Re: S/D 88-46 - Ashley Park Addition (Formerly Greystone  
Addition)

EXHIBIT "A" - S/D 88-46  
ASHLEY PARK ADDITION, FINAL PLAT  
COMMENTS APPROVED BY THE S/D COMMITTEE 7/28/88

CASE NUMBER: S/D 88-46 - GREYSTONE ADDITION

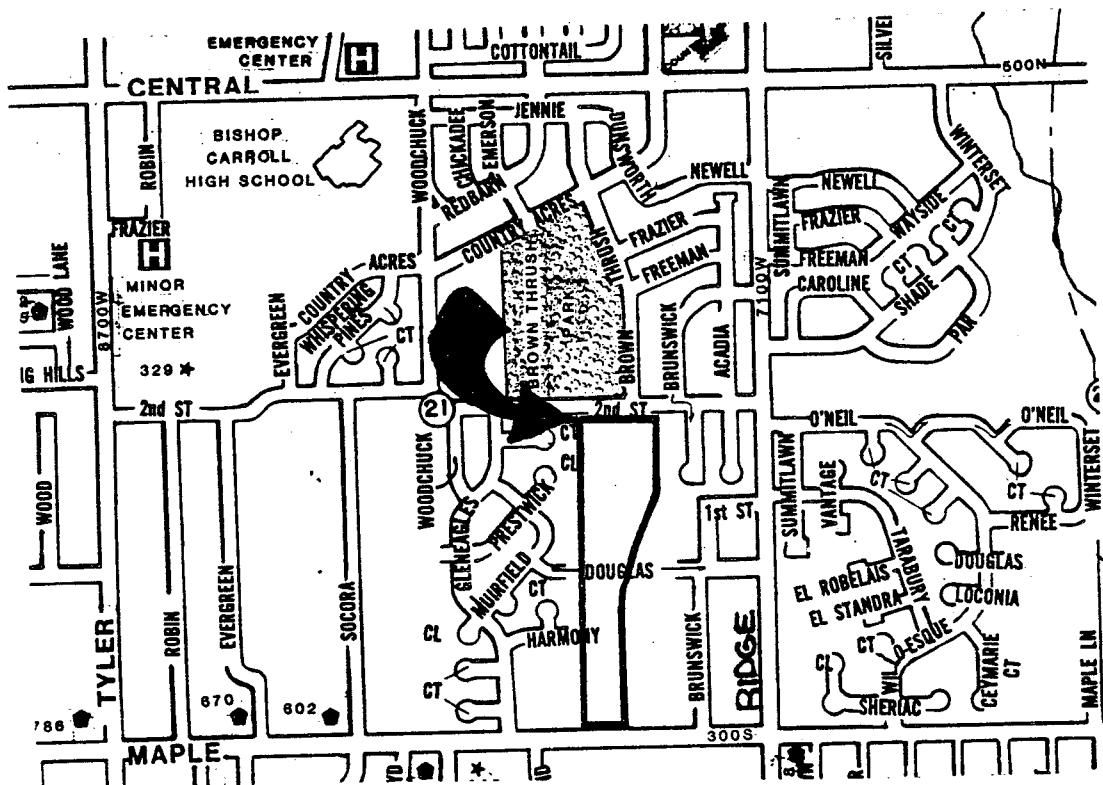
- A. The applicant shall guarantee the extension of City water to serve the lots being platted.
- B. The applicant shall guarantee the extension of sanitary sewer to serve the lots being platted.

- C. The applicant shall guarantee any drainage improvements required by the platting of this property.
- D. The applicant shall guarantee construction of the storm sewers required by this plat.

- E. The applicant shall guarantee the paving of the proposed interior streets.
- F. As required by the sidewalk ordinance, a sidewalk shall be installed along one side of Greystone from Maple to Second Street (see comment I). This is a long continuous street, connecting an arterial to a collector. The area north of this plat is also the location of a City Park, a junior high school and a high school. The construction of this sidewalk shall be provided for in the paving petition for the associated street.

- H. Since Second Street at this location is classified as a collector street, the applicant shall submit a notarized sidewalk certificate stating that a sidewalk will be constructed adjacent to Second Street at the time of Lots 28 through 33 and Lots 44 through 46, Block 3's development.

- I. Greystone shall be extended to connect with Second Street. This connection is needed in order to provide a more direct means of emergency access to the lots in the northern portion of this plat. Such a connection is also needed to avoid an undue diversion of traffic into the addition to the west of this site and the circuitous travel patterns that would be involved to gain access to the public park, commercial areas and schools north and west of the addition.

- J. On the final plat, complete access control shall be indicated to Second Street across the north line of the lots being platted adjacent to Second Street.

- R. The final plat shall label the centerline of the utility easements.
- S. On Lots 38, 54, 63, 66, 67 and 71, Block 3, the 20-foot utility easement adjacent to the west line of these lots shall also be labeled as a building setback.

- U. On the final plat, the platting of the 5-foot wall easement shall be referenced in the plattor's text. If utilities need to cross the wall easement, this should also be indicated in the plattor's text.

- V. Prior to, or at the time of submitting the final plat, the applicant shall submit a drainage plan to City Engineering for review and approval.
- W. The applicant's engineer is advised that the Register of Deeds is requiring the name(s) of the notary public, who acknowledges the signatures on this plat, to be printed beneath the notary's signature.

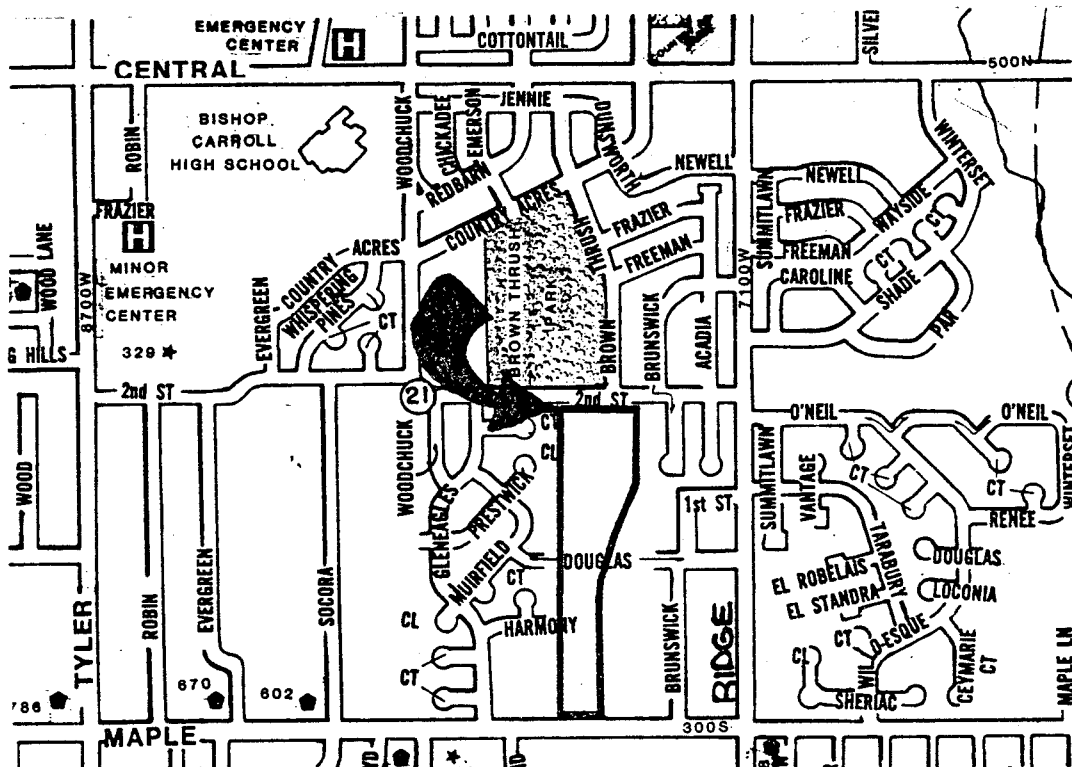
- E. The applicant shall guarantee the paving of the proposed interior streets.
- F. As required by the sidewalk plan, the paving petition for Brown Thrush shall provide for a sidewalk on the east side of the street from 2nd Street to sidewalk easement between Lots 9 and 10, Block 4. The paving petition for Ashley Street shall provide for a sidewalk on the east side of the street from the south line of Lot 32, Block 4, to the north line of Maple Street.

- G. As required by the sidewalk plan, the applicant shall guarantee the construction of a sidewalk within Reserve A and the sidewalk easement between Lots 9 and 10, Block 4 (approximately 2,200 linear feet).

- Q. It is noted that the perimeter of this final plat includes property previously acquired by the City as a drainage easement. This is acceptable so long as a title or abstract company can certify that ownership is vested with the plattor. If the perimeter on the final plat tracing excludes the adjacent drainage easement from this plat's perimeter, the recording information for the adjacent easement shall be properly referenced on the face of the plat. If title to the adjacent drainage easement cannot be acquired by this plattor, changes to this plat's drainage plan may be required.

- U. Perimeter closure computations shall be submitted with the final plat tracing. Section 5-101(C).
- V. Recording of the plat within 30 days after approval by the City Council.
- W. The representative from the City Engineer's office should be prepared to comment on the status of the applicant's drainage plan. Specifically, what drainage guarantees are required for this subdivision.
